## Pellet Feeder - Indirect Drive

### Change :

New Ultra Feeder

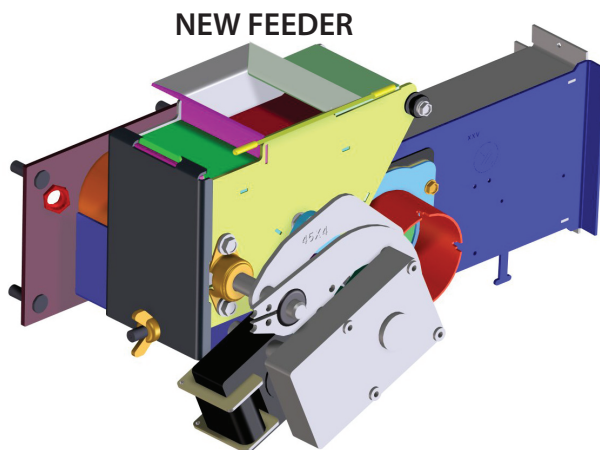
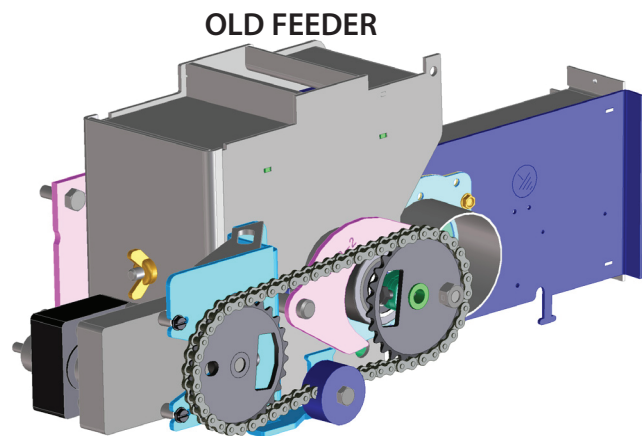
Compact Size. Service Friendly(increased internal visibility). Internal airflow built in.

The Ultra Feeder is a more compact design, *no chain drive system needed.*

The Ultra Feeder is sealed at the hopper throat with a replaceable gasket. No need for cutting silicone.

The original feeder body cannot be replaced with an Ultra Feeder. Replacements for old feeders will remain available, part# 1-10-677150.

Feed motor removal involves loosening one set-screw bolt(7/16" wrench), and slide the motor out of the auger. If the motor is stopped in a un-reachable position, loosen the auger retainer bolts(1/2" wrench) and slide the auger out of the feeder, to access the motor set-screw.
